# LiDAR Quality Assessment Report

LA-USGS\_Atchafalaya2\_2012

LA\_Atchafalaya-2\_2012

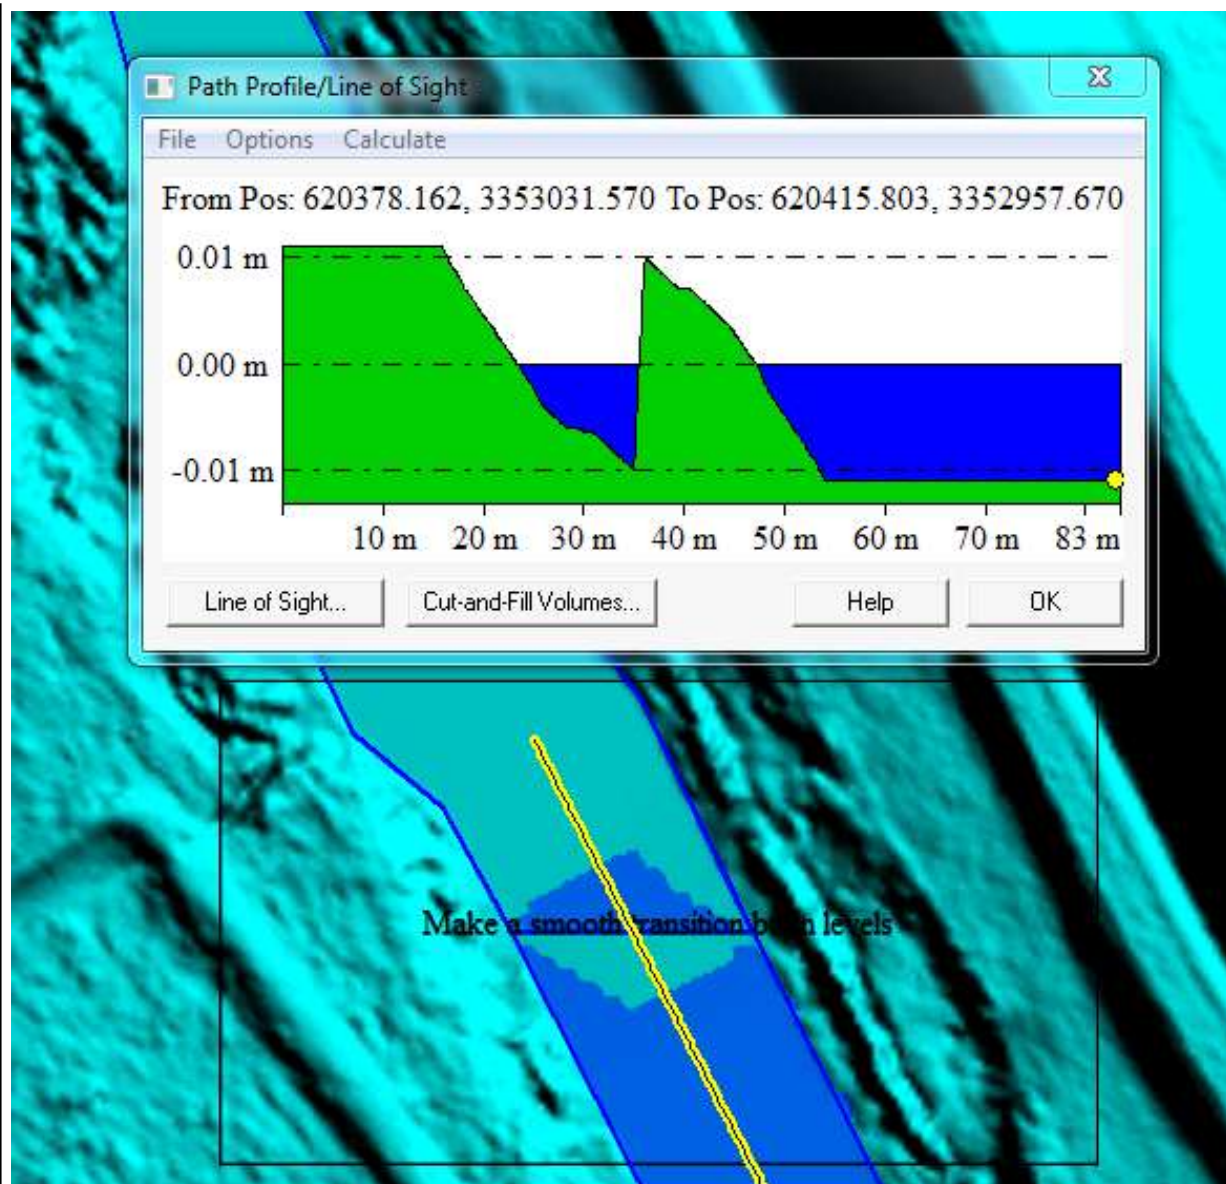
Should have a smooth change in water levels.

\*\*\*Vendor corrected the image above.

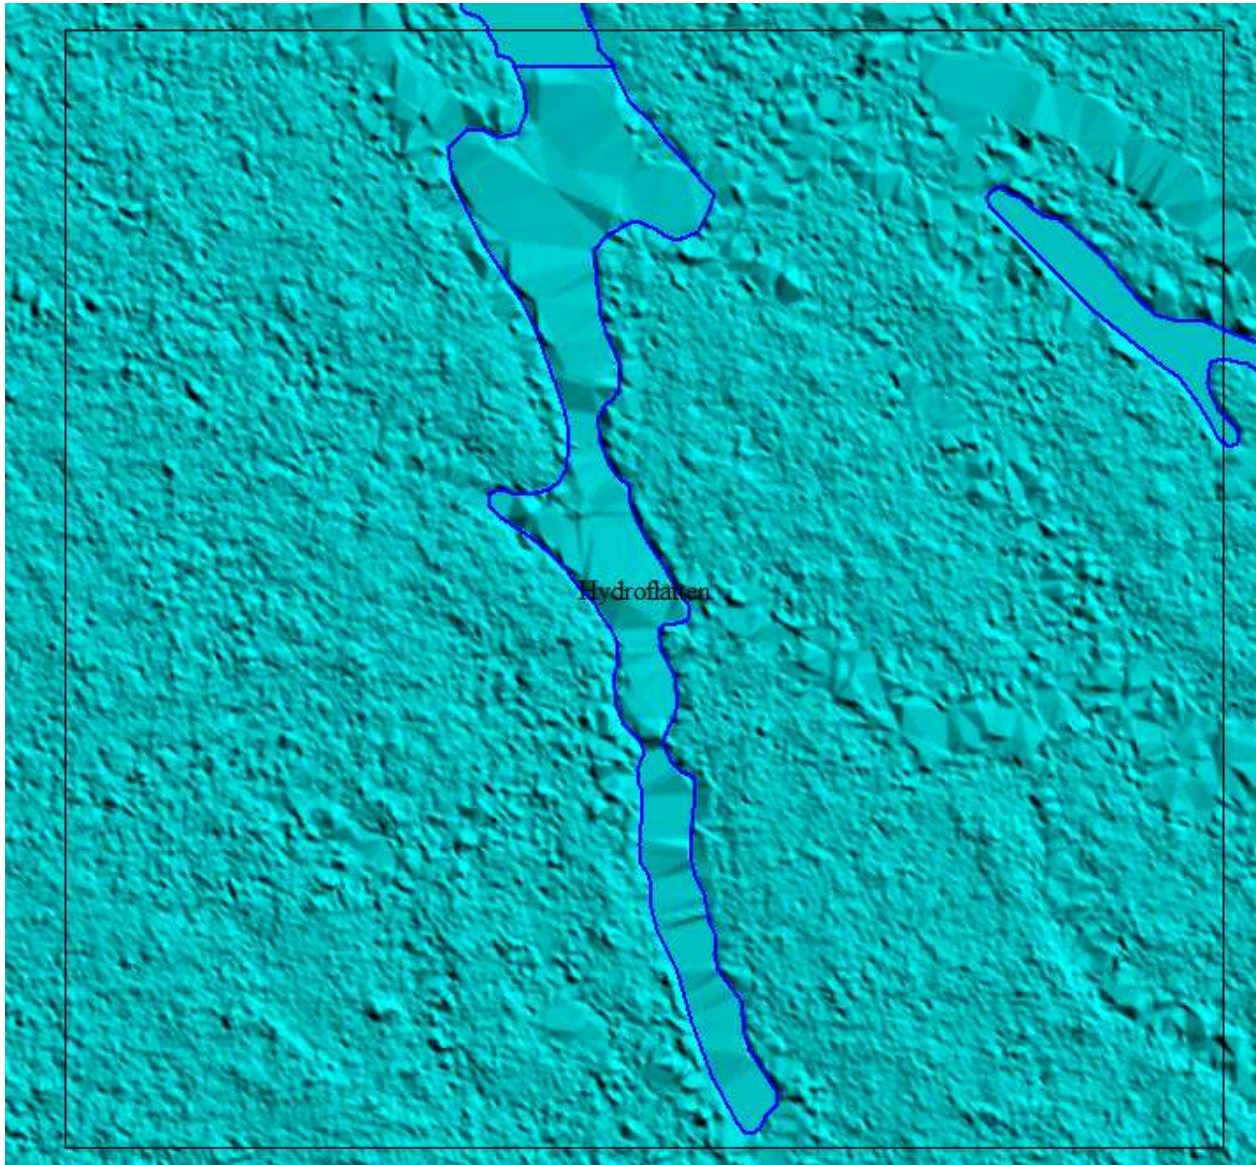
Hydroflatten stream. This is a representative image only. Several types of this error exist.

\*\*\*Vendor corrected the image above and other errors of this type.

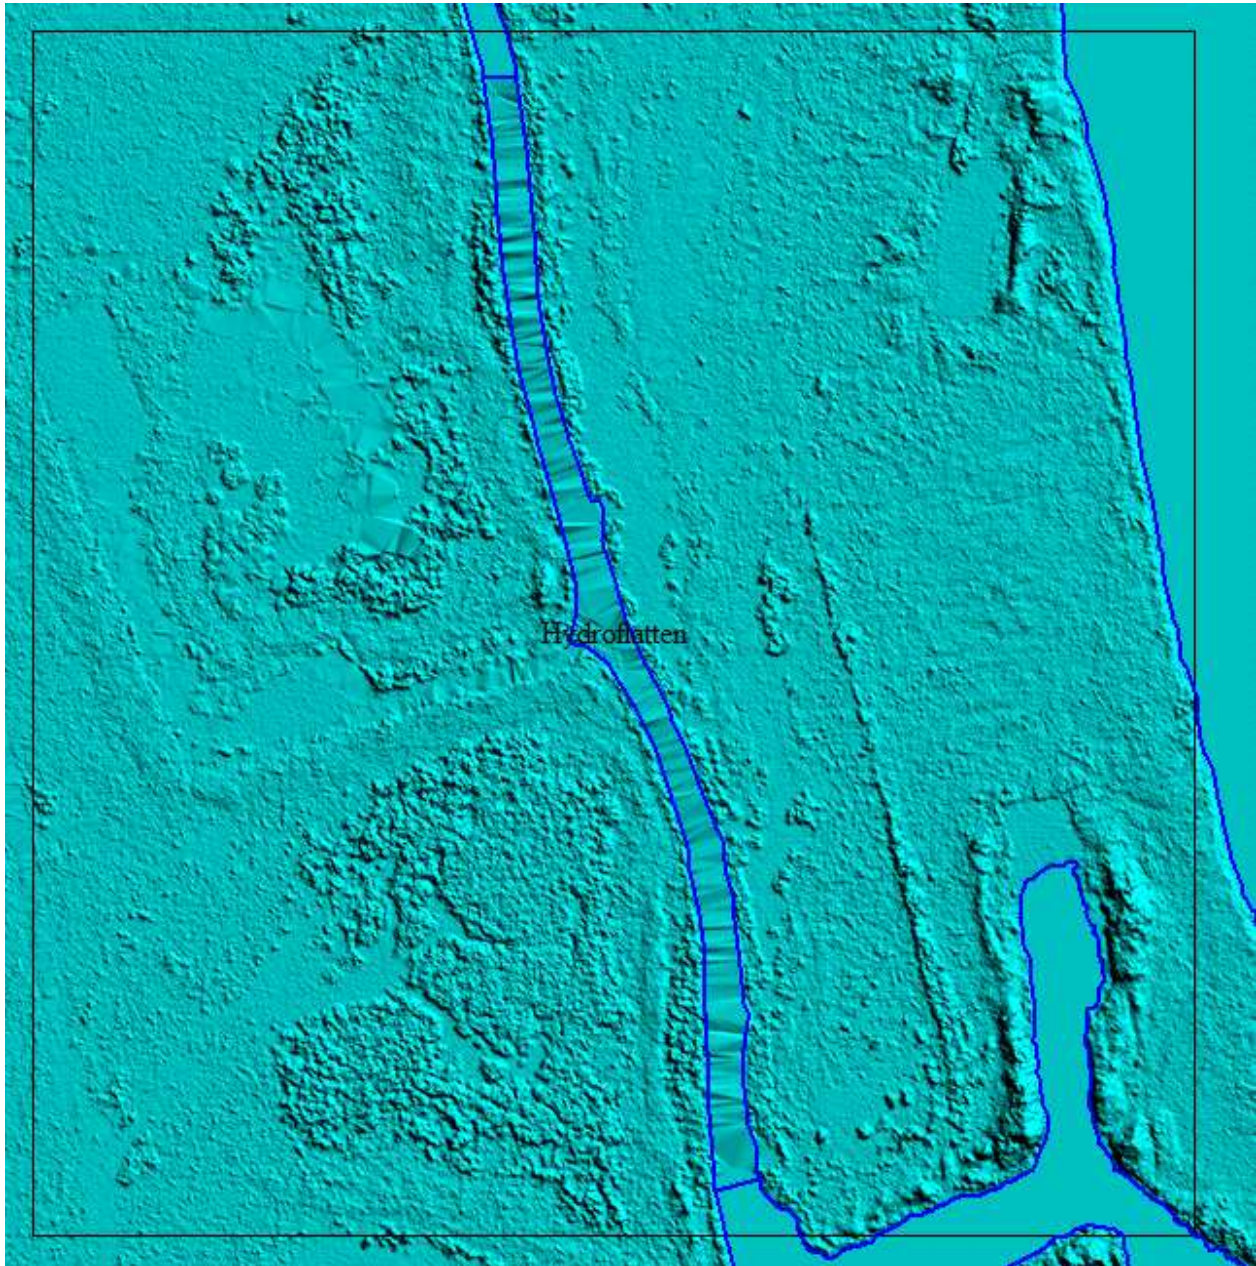
DEM Tile mismatch. This is a representative image only. Several types of this error exist.

\*\*\*Vendor corrected the image above and other errors of this type.

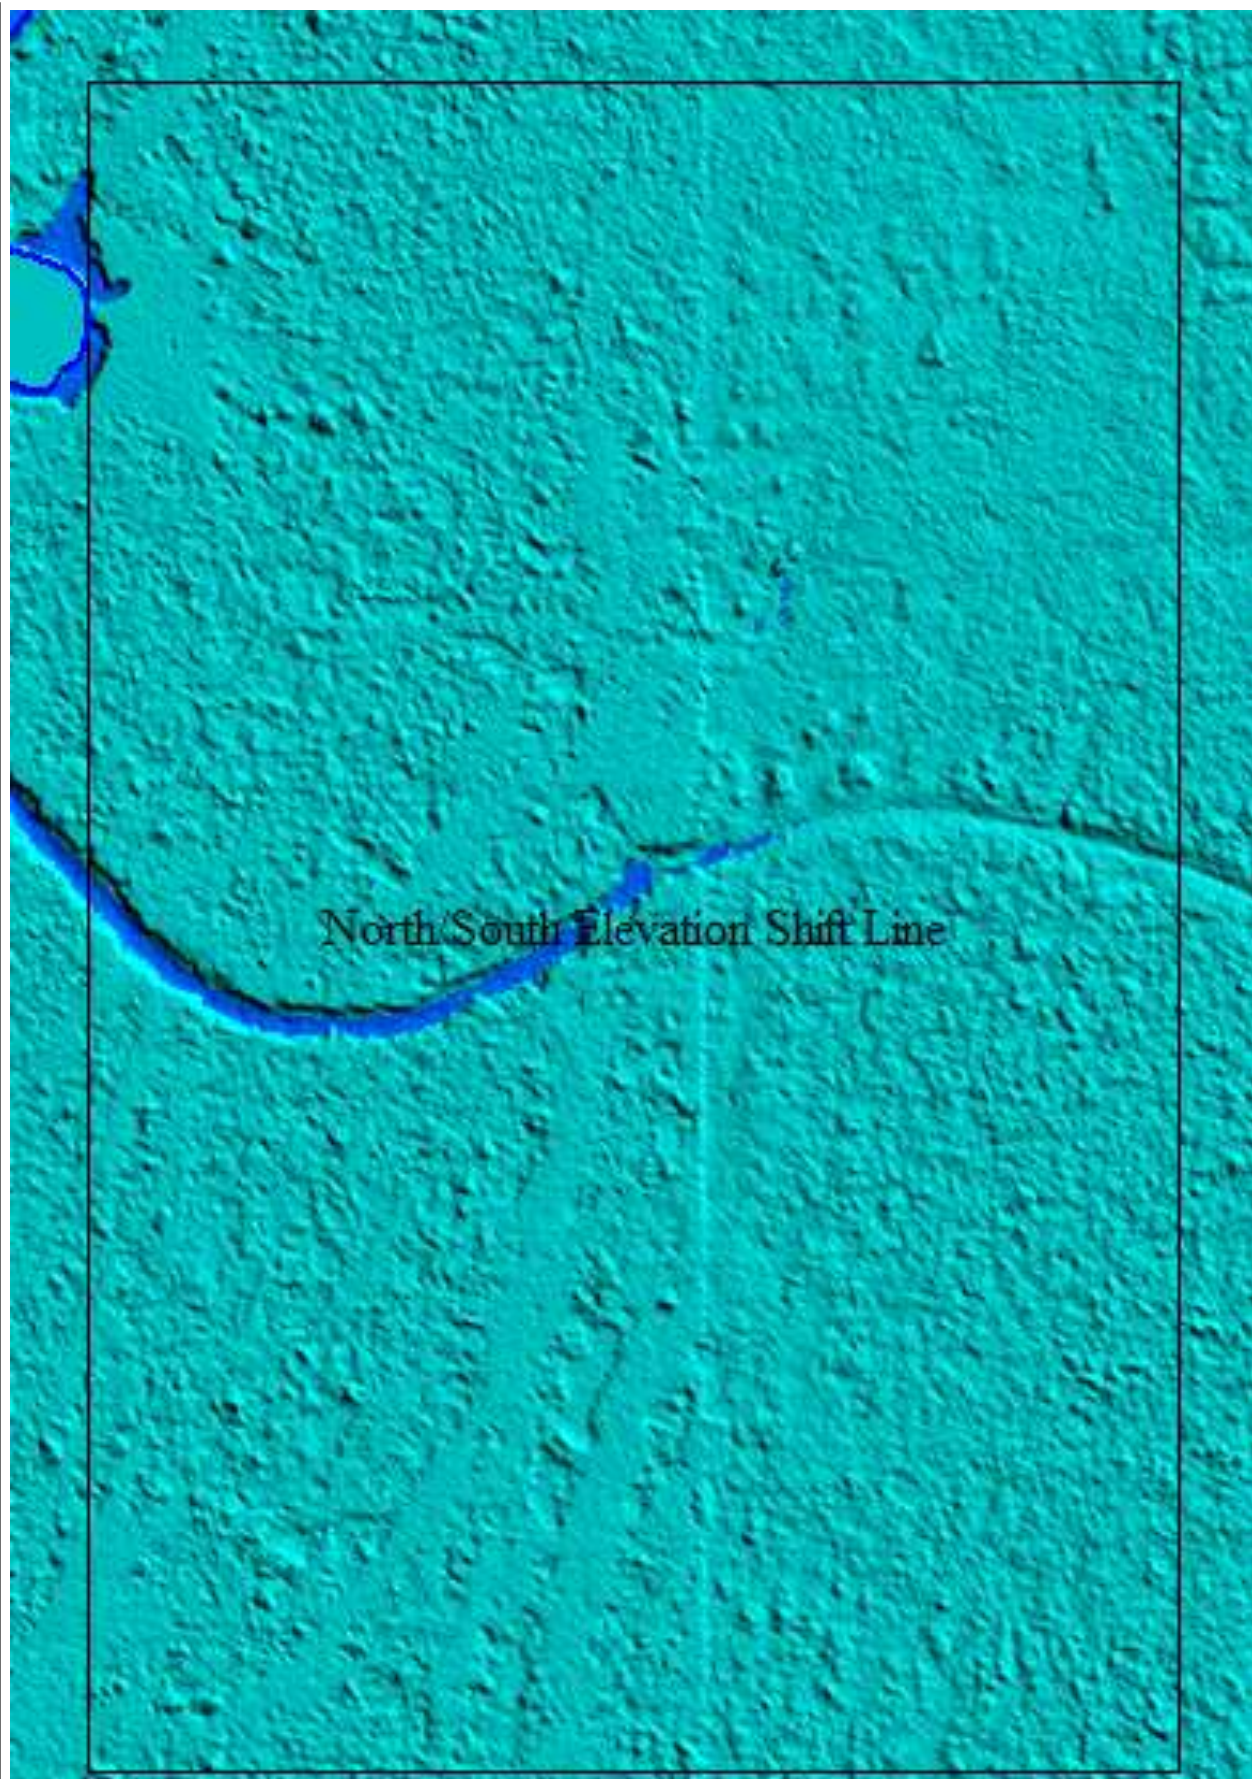
Hydroflatten stream. This is a representative image only. Several types of this error exist.

\*\*\*\*Vendor corrected the image and other errors of this type.

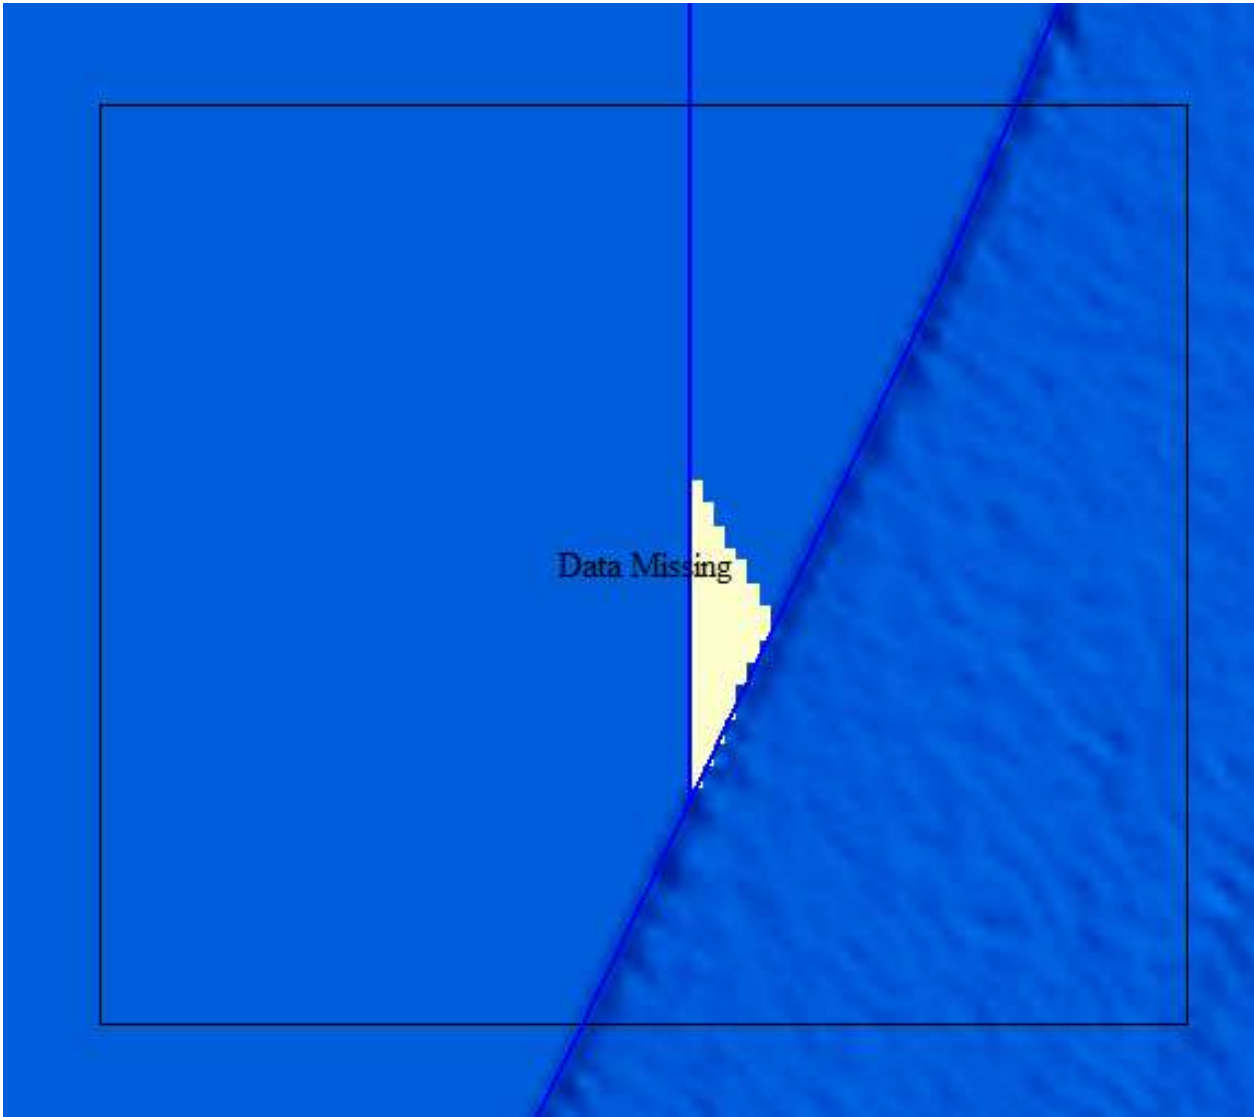
Data missing. This is a representative image only. Several types of this error exist.

\*\*\*Vendor corrected this error.

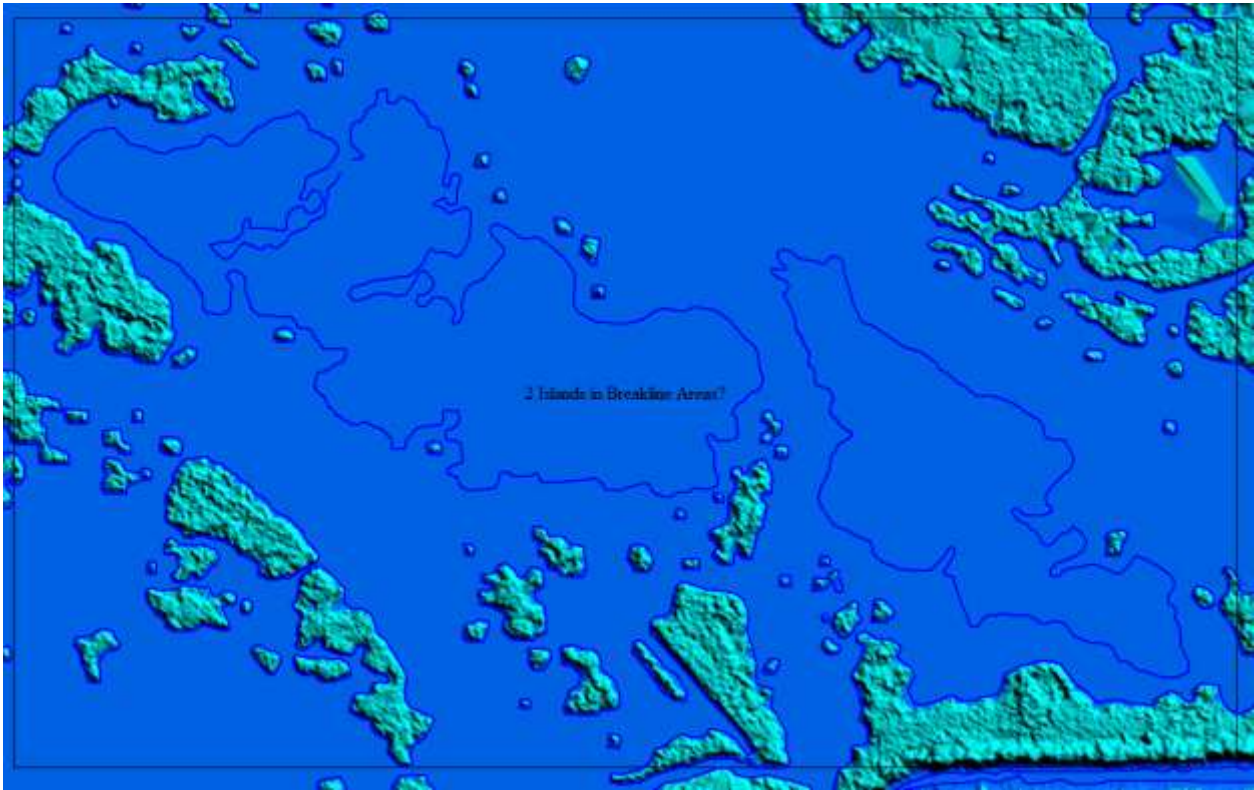
Missing 2 islands.

\*\*\*Vendor corrected this error.
